Swan and Canning Rivers Management Act 2006

DETERMINATION OF DEVELOPMENT APPLICATION

SWAN RIVER TRUST REPORT

PROPOSAL : Refurbishment of Matilda Bay Tea Rooms
COST : \$500,000
LOCATION : Lot 8168 and 8169 on Plan 171833 (Crown Reserve
17375)
5 Hackett Drive, Crawley
APPLICANT : Matilda Bay Tea Rooms
Redbridge Pty Ltd as Trustee for Kiosk Unit Trust
LANDOWNER : Department of Parks and Wildlife
LOCAL GOVERNMENT : City of Subiaco
MRS CLASS'N : Parks and Recreation
LA CLASS'N : Parks and Recreation
DECISION TYPE : Part 5, *Swan and Canning Rivers Management Act*
2006 – Ministerial Determination
RECEIVED : Application form: 13 August 2014
Original plans: 13 August 2014
Amended plans: 15 October 2014
ATTACHMENTS

Attachment 5b - amended plans showing planter box

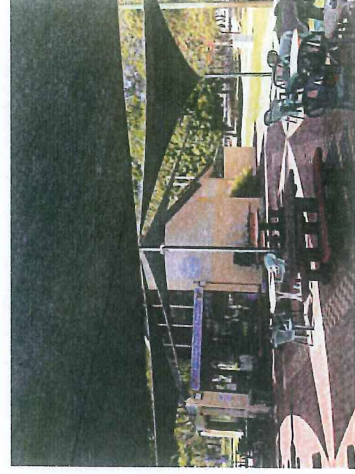
- 7.22 Further, the landscaping included in the planter box will soften the impact of the building and improve the visual appearance of the facility without impacting too much on views through from Hackett Drive to the river.

14. The plants within the new planter box shall be the responsibility of the applicant and shall be maintained in good condition at all times.
15. The maximum seating capacity of the premises within the leased area shall be limited to 134 persons at any one time.

EL.04
DA.02
NORTH ELEVATION
1:100

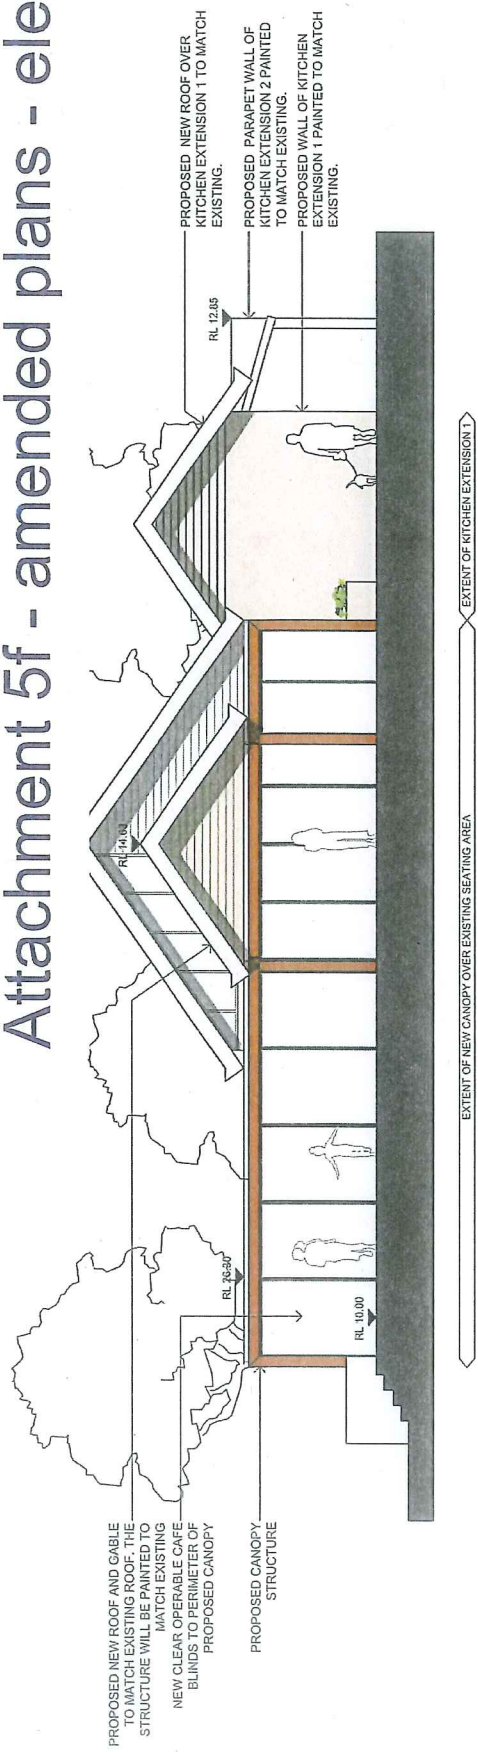
- Ensure lease boundary and proposed or refurbished spaces are clearly indicated on plans for all future drawings
- Create minimum 3m wide path against north elevation to provide sufficient entrance to tea rooms and access to river terrace
- Proponent to ensure quality materials (painted timber or similar robust cladding) used for storage areas under main roof. Colours may be more vivid for these elements than indicated in the Guidelines
- Consider new tea rooms signage be designed specifically for parapet wall module for kitchen extension 2 facing Hackett Drive
- Remove low height walls between storage areas
- Consider neat interface between café blinds and storage areas. Likely to trap debris, leaf litter, rubbish etc.

16. The lighting design plan required under **Condition 5** shall be implemented.
17. The paved route along the northern edge of the new pavilion shall be a minimum 3 metre width to allow for adequate public access around the facility. The paved route around the west and southern sides of the building shall be a minimum 2 metre width.
